SERVICE NEWS

PUBLISHED BY
CHEVROLET TECHNICAL
SERVICE DEPARTMENT

JANUARY, 1965

LATEST 1965 BODY SERVICE MANUAL CHANGES

Fig. 2—Six-Way Transmission Components

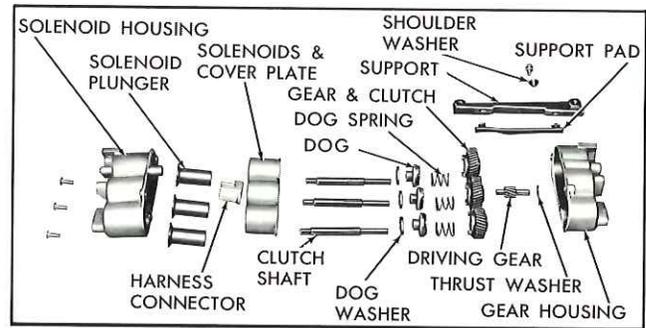
Figure 1H-15 revised to include reference arrows. (Fig. 2).

Fig. 4—V-8 (283 or 327 cu. in.) Engine Dip Stick Modification

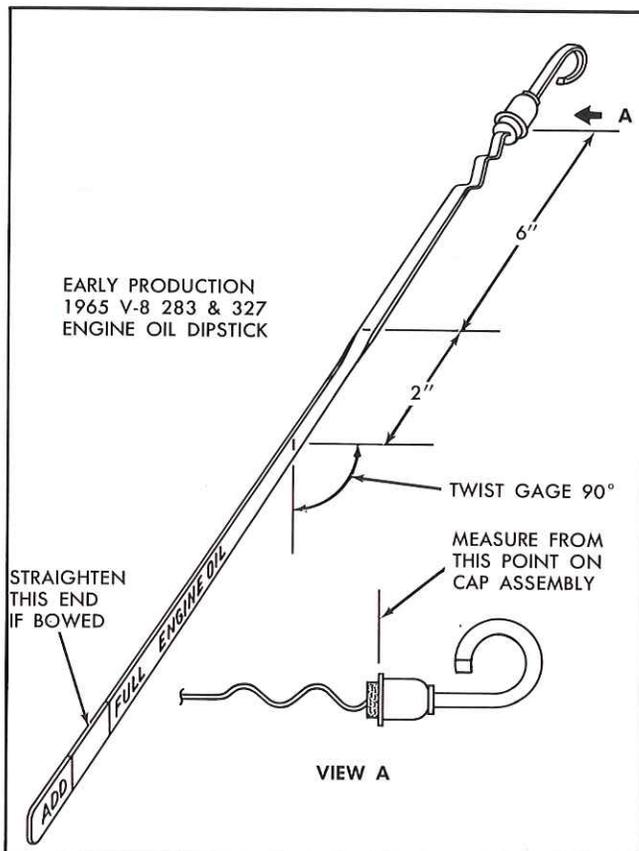
Field reports indicate early production 1965 Model Chevrolets, Chevelles and Corvettes equipped with 283 or 327 cu. in. V-8 engines may have an oil dip stick that is too flexible.

When cases of erratic oil level readings are reported it is recommended that the oil dip stick be modified as shown in Fig. 4. The dip stick must first be straightened, particularly at the lower end, and then twisted 90° as illustrated.

Fig. 6—Bearing Puller J-7112 Modification

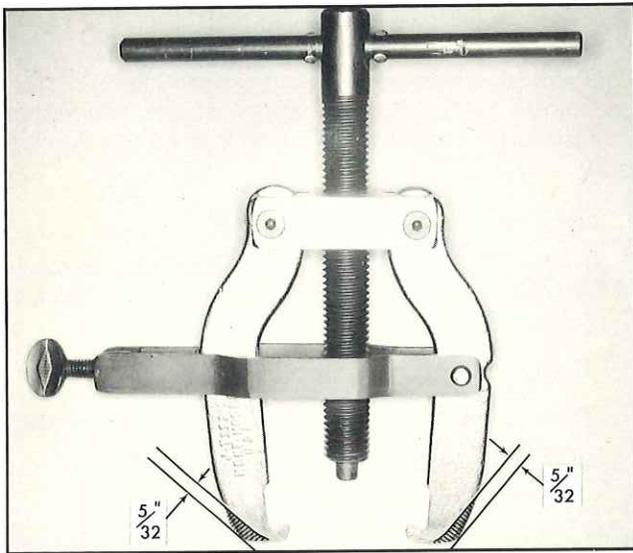
Two tool revisions are released for use with the 1965 Corvair differential assembly when replacing side bearings. Modify Bearing Puller J-7112 by grinding the outer radius of the pulling legs as shown in Figure 6 to allow entry into the cover cavities for correct engagement of the side bearing inner race.

Fig. 8—Telescoping Steering Wheel Horn Button Liner

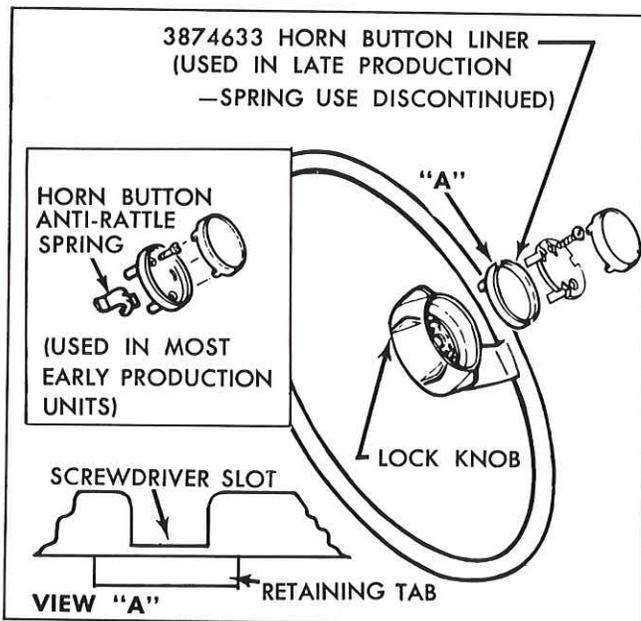
The horn button plastic liner shown in Fig. 8 is now being installed on late production 1965 Corvairs and Corvettes equipped with Telescoping Steering Wheel (RPO N36). The 3874633 Horn Button Liner provides a significant reduction in horn blowing effort. It also acts as an improved anti-rattle device for the horn button and should now be used, in place of the 3868785 anti-rattle spring, as correction for severe horn button vibration problems on early production cars.

Figure 8 shows the installation of the Liner and the screw driver slot. The slot permits service removal of the horn button cap if required at some other time. It is only necessary to remove the horn button cap to install the liner; however, on jobs equipped with the anti-rattle spring, the spring must be discarded if the Liner is being installed for any reason.

Fig. 9—Power Window Ground Wire Added

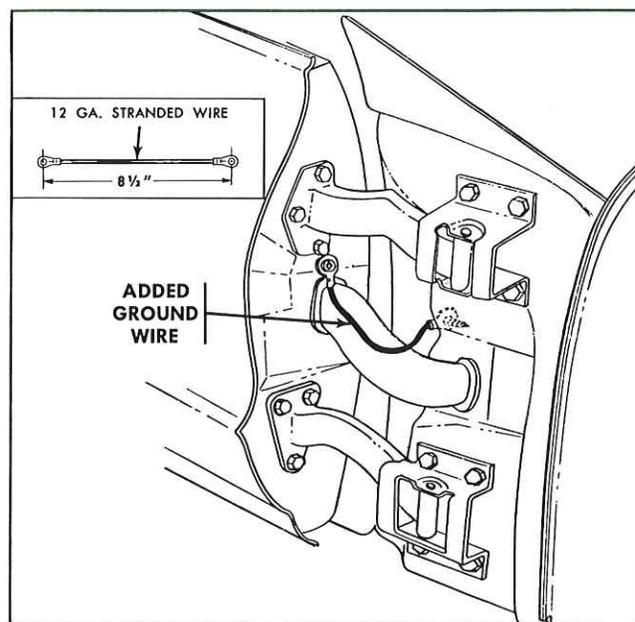
If intermittent operation of power windows is experienced on 1965 body styles, one of the causes can be insufficient electrical ground between the door and the body. When this condition is encountered, a ground wire should be fabricated in the shop and installed between the door hinge pillar and the body hinge pillar. One recommended location for attachment is illustrated in Figure 9; however, if another location is desired, precautions should be taken to prevent the ground wire from being pinched or chafed when the door is opened or closed.

On body styles where screws retain the wiring conduit on the door hinge pillar, the ground wire may be inserted under the rubber lip and screw for grounding.
